**SECTION 00 9112
ADDENDUM NUMBER TWO**

PROJECT: IOWA STATE FAIR – SWINE-CATTLE BARN UPDATES – PHASE 1

RE: Structural Addendum

PROJECT : ISF Swine – Cattle Barn UPDATES – Phase 1

SR072525-1

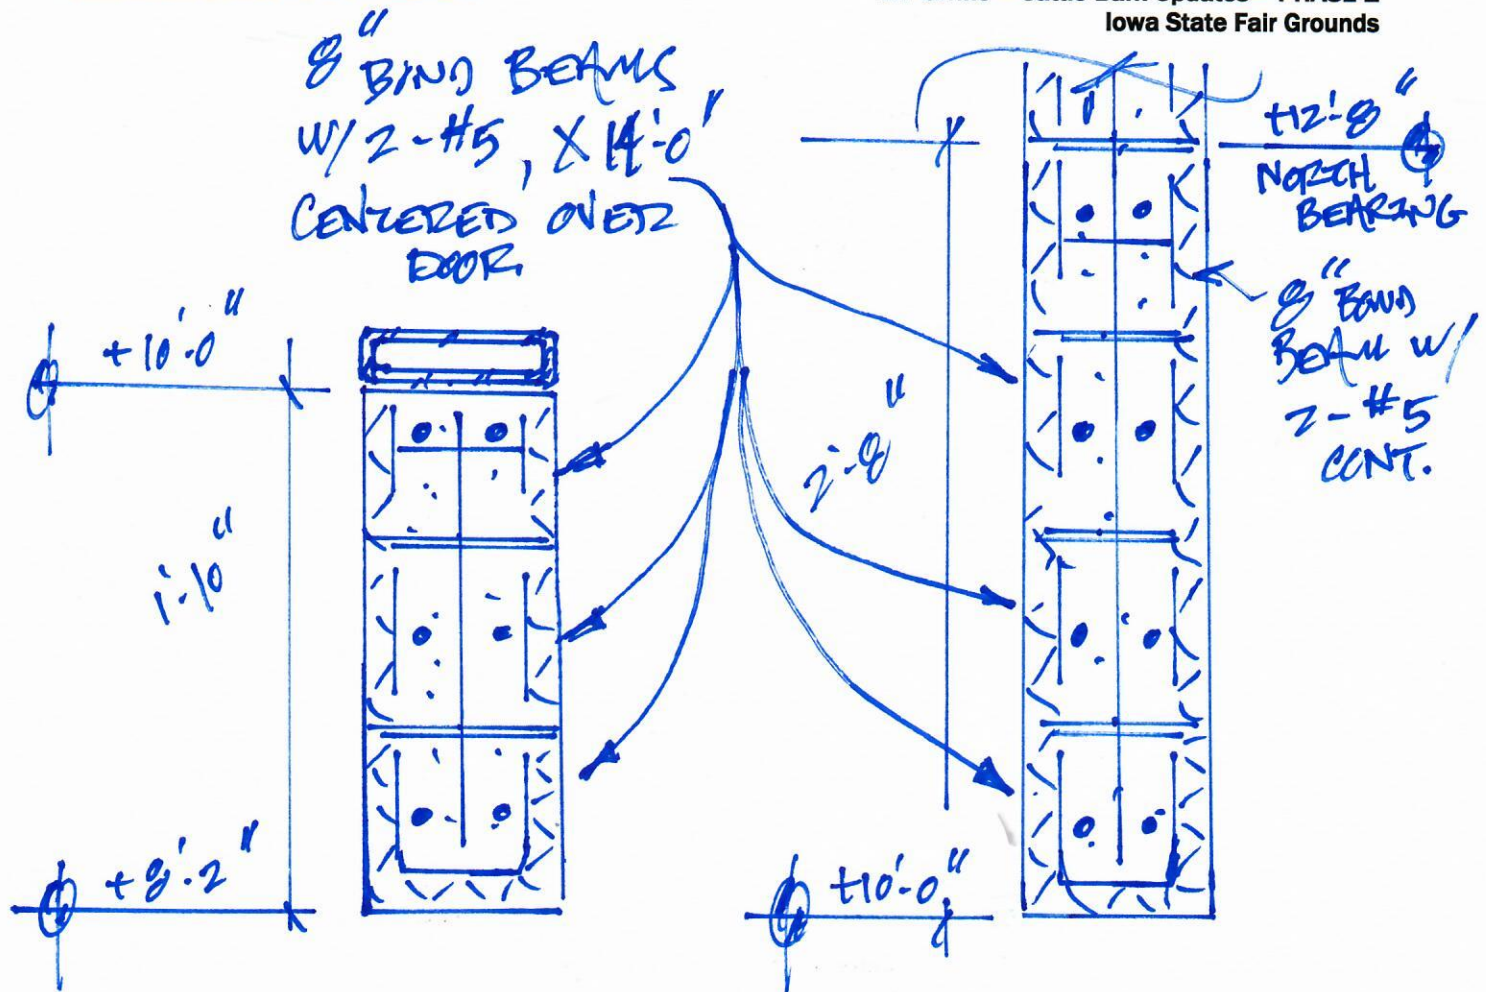
1. See attached SR072525-1 drawing which clarifies plan 1/S101-1 with the limits and extents of the 8" wide concrete starter wall – shaded in GREEN. Also provides clarification to the cross walls and footings. Also included are clarifications to the size and types of footings at the north and south ends.

PROVIDE 8" WIDE
STAZLER WALL
WHERE WALL
HIGHLIGHTED
GREEN -
TOC +0'-2"

- OTHER W/SE
CMU BEAMS ON
FOOTING AT -1'-2"
AT CHASE WALL
AND CROSS WALLS
NOT HIGHLIGHTED.

SR072525-2

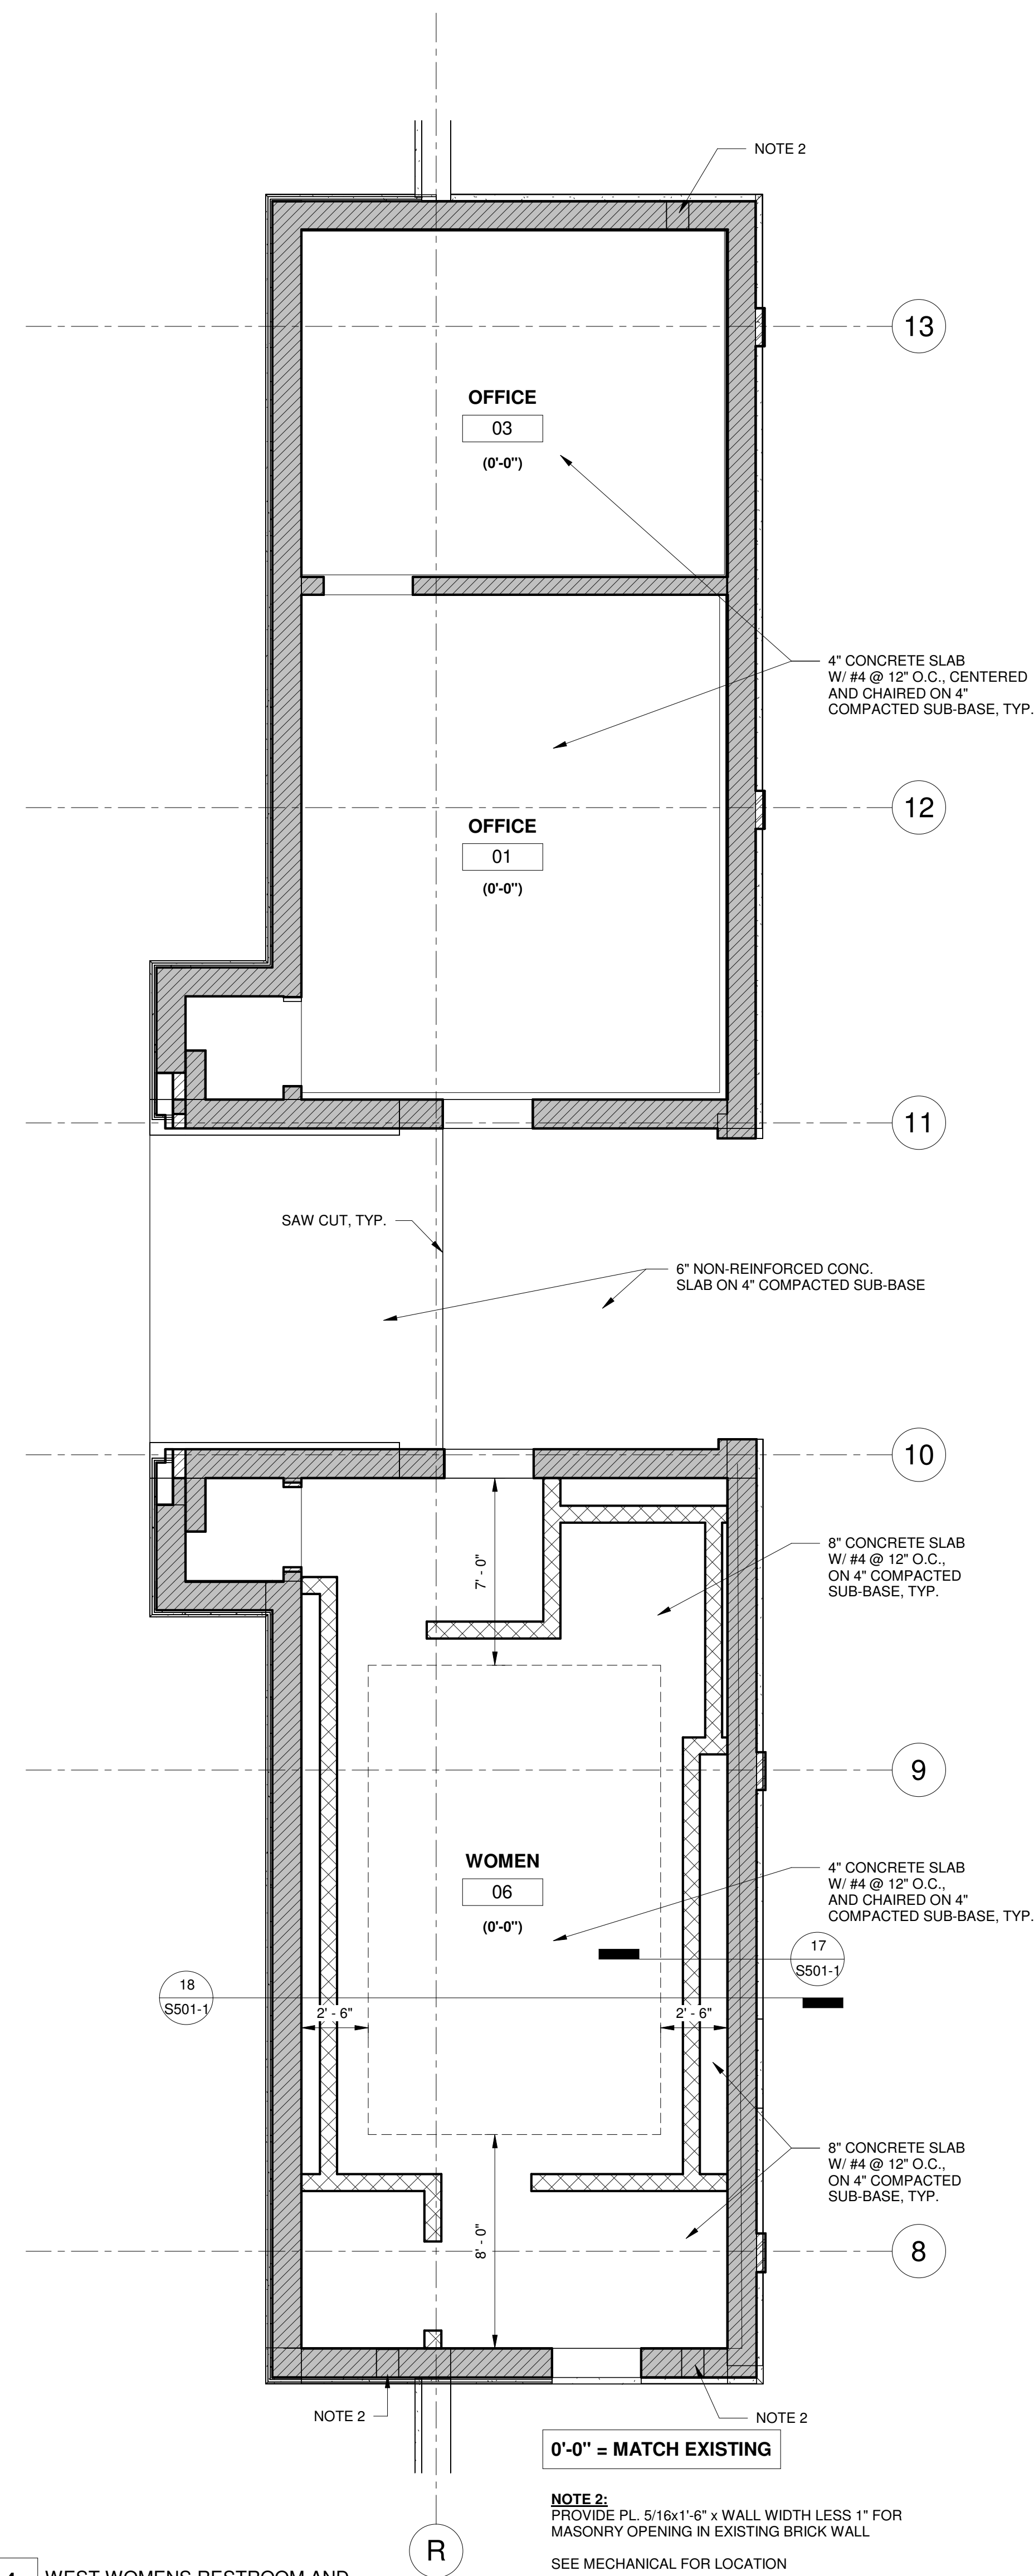
12. Replace Lintel 2 detail 2/S502-1 as indicated on the attached SR072525-2.
13. Detail 4/S502-1 has been fixed aligning plate and column.

15. Replace Lintel 2 detail 2/S504-1 as indicated on the attached SR072525-2.

SWINE BARN L2 LINTEL
1/2" = 1'-0" (REPLACES
2/S502-1)

CATTLE BARN L2 LINTEL
1/2" = 1'-0" (REPLACES
2/S504-1)

S101-1

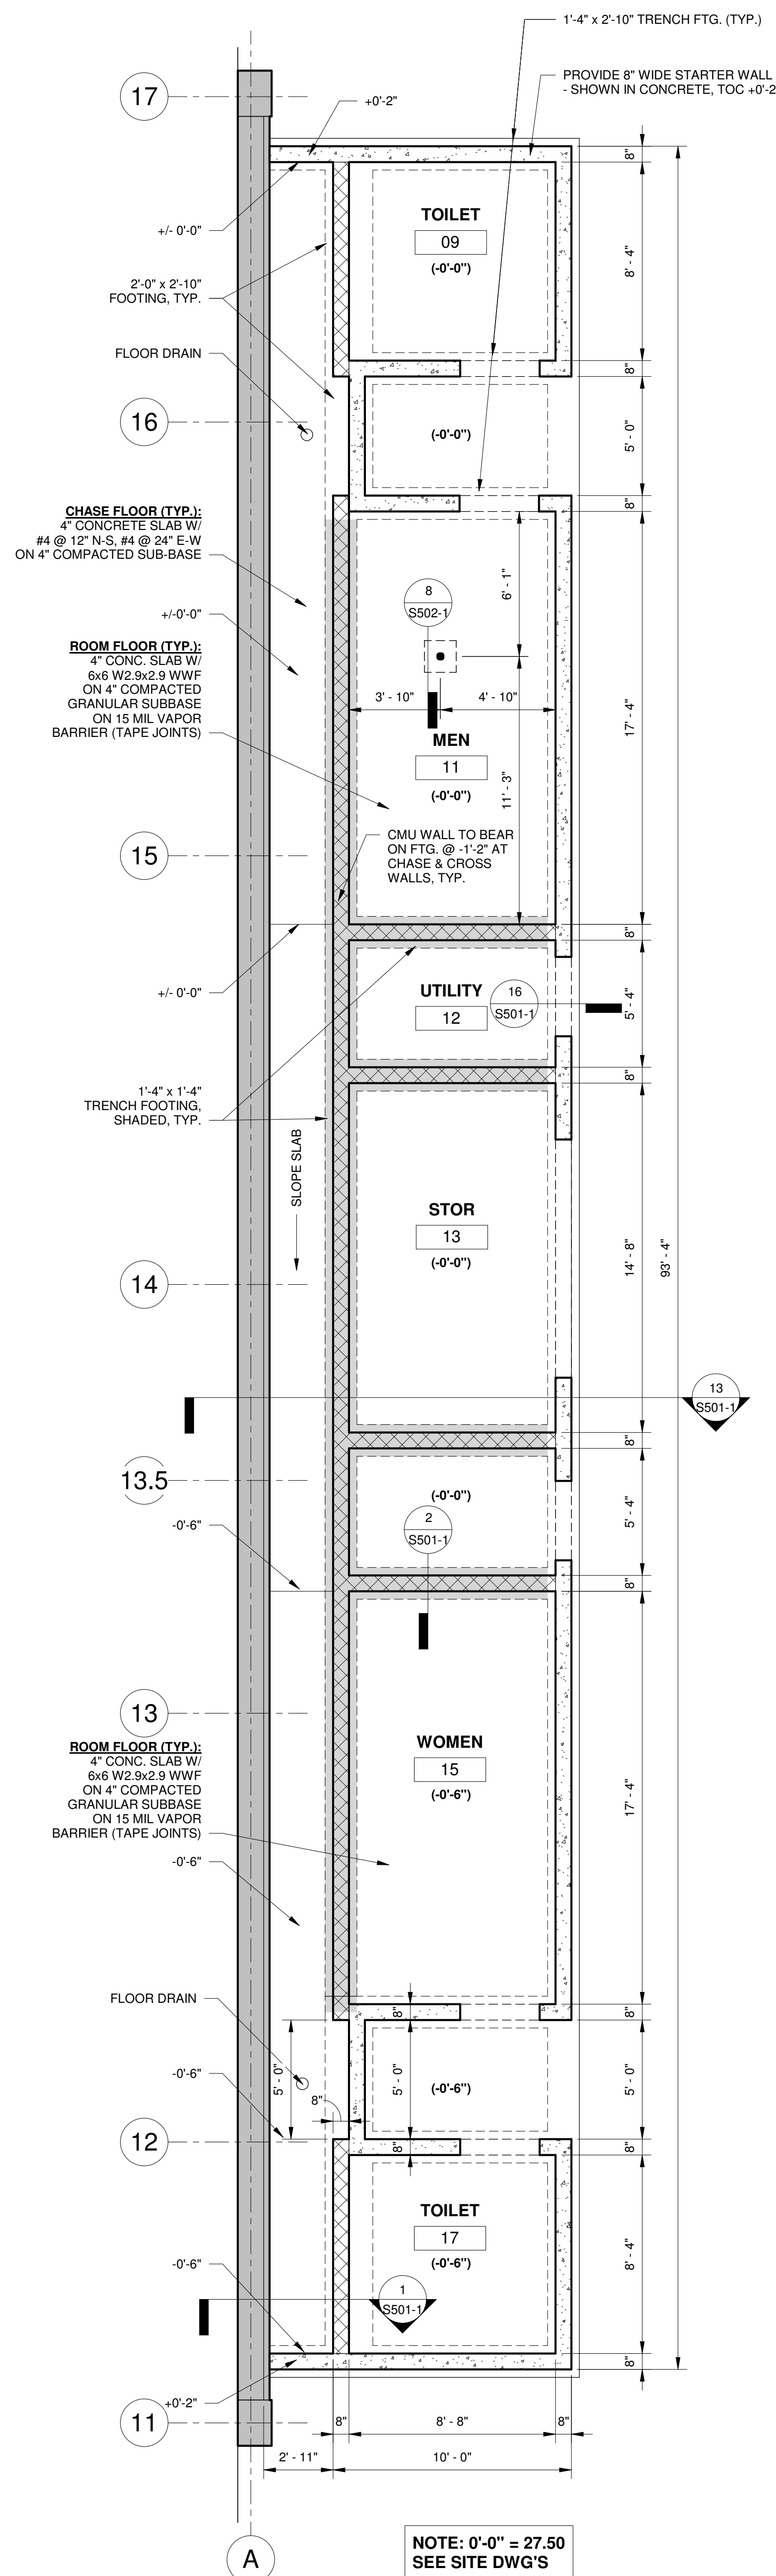
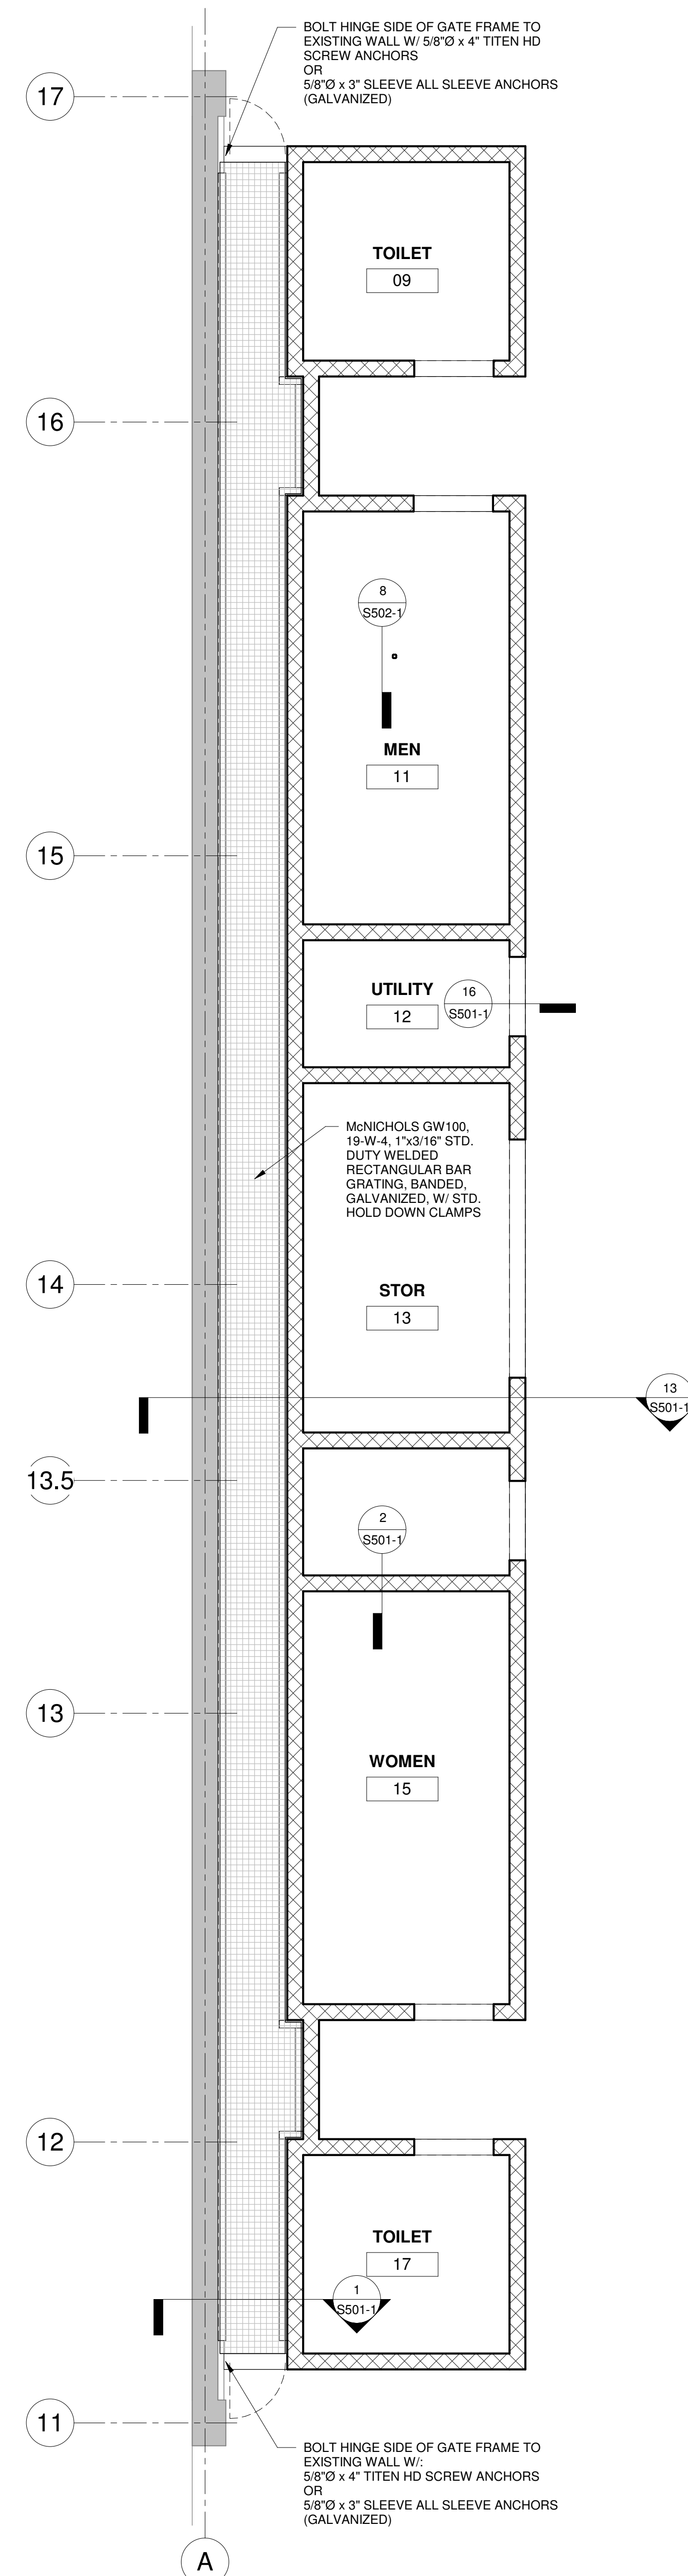
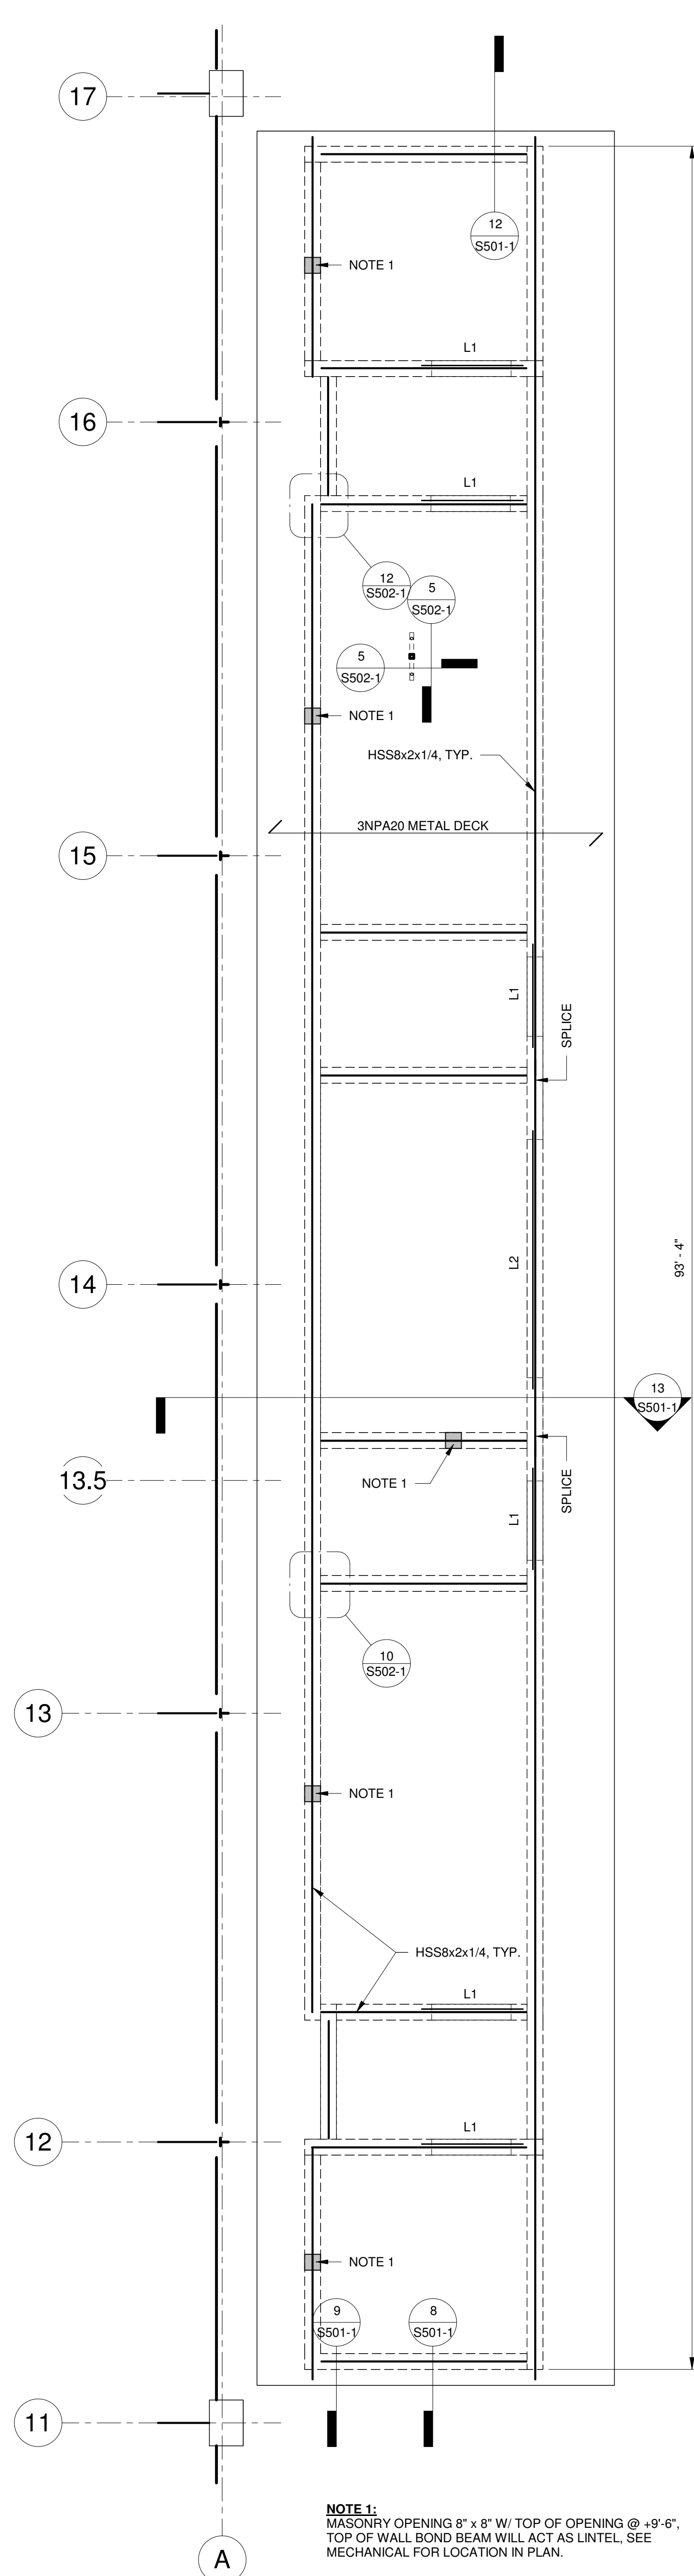
2. Add note to plan 1/S101-1 all rooms other than the Chase as follows:
FLOOR SLAB TO BE 4" CONCRETE WITH 6X6 - W2.9XW2.9 WWF, ON 4" COMPACTED GRANULAR SUBBASE ON 15 MIL VAPOR BARRIER (TAPE JOINTS).

3. Change plan 2/S101-1. North and South edge of roof line actually closer to the building – see detail 8/S501-1.
4. Correct plan 2/S101-1. The number and locations of NOTE 1 have been changed to match mechanical. See Mechanical sheet M102-1 for actual locations and provide NOTE 1 for each.

5. Correct plan 12/S101-1. The number and locations of NOTE 2 have been changed to match mechanical. See Mechanical sheet M102-1 for actual locations and provide NOTE 2 for each.
